REFERENCE:	TSB: 18-008-24 GROUP: 18 - Vehicle Performance	Date:	January 25, 2024	REVISION:	18-055-22 REV. A
VEHICLES AFFECTED:	2020 (DD) RAM 3500 Cab Chassis 2020 (DP) RAM 4500/5500 Cab Chassis This bulletin applies to vehicles equipped with a 6.7L I6 Cummins Turbo Diesel Engine (Sales Code ETN).			MARKET APPLICABILITY: <input checked="" type="checkbox"/> NA <input type="checkbox"/> MEA <input type="checkbox"/> SA <input type="checkbox"/> IAP <input type="checkbox"/> EE <input type="checkbox"/> CH	
CUSTOMER SYMPTOM:	<p>Customers may experience a Malfunction Indicator Lamp (MIL) illumination. Upon further investigation the technician may find one or more of the following Diagnostic Trouble Codes (DTCs) have been set:</p> <ul style="list-style-type: none"> ● P0506-00 - Idle Control System RPM - Lower Than Expected. ● P0607-00 - ECU Internal Performance. ● P20E8-00 - Reductant Pressure Too Low. ● P0301-00 - Cylinder 1 Misfire. ● P0302-00 - Cylinder 2 Misfire. ● P0303-00 - Cylinder 3 Misfire. ● P0304-00 - Cylinder 4 Misfire. ● P0305-00 - Cylinder 5 Misfire. ● P0306-00 - Cylinder 6 Misfire. ● P0299-00 - Turbocharger Underboost. ● P1D73-00 - AGS Performance. ● P0626 - Generator Field Con

Fig. 1

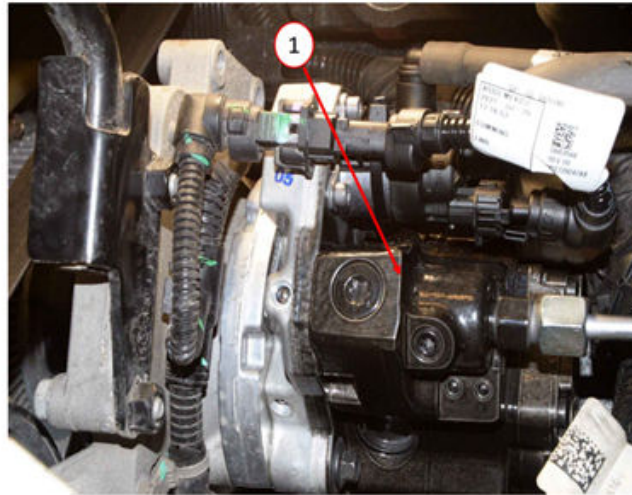
NOTE: The only calibration available will be for the updated CP3.3 design high-pressure fuel injection pump **Fig. 1**. Please ensure that recall Y78 has been completed first before proceeding with this update.

1. Inspect the high-pressure fuel injection pump **Fig. 1** to verify which pump is currently installed on the vehicle. **Also review the vehicle VIP report to see if campaign Y78 has been performed.**

2. Does the VIP report indicate that Y78 has been performed and is the vehicle equipped with the new design fuel injection pump released under the campaign?
 - YES >>> Proceed to [Step 3](#).
 - NO >>> **Perform the Y78 campaign first.** Once the campaign is performed, new pump installed and PCM updated, the PCM will have all of the updates listed in this document. **This Bulletin does not apply.**
3. Reprogram the PCM/ECM with the latest software. Detailed instructions for flashing control modules using the wiTECH Diagnostic Application are available by selecting the application's "HELP" tab.
4. Clear any DTCs that may have been set in any modules due to reprogramming. The wiTECH application will automatically present all DTCs after the flash and allow them to be cleared.
5. Using wiTECH, perform the "Oil Life Restore" procedure located in the ECM "Misc Functions".
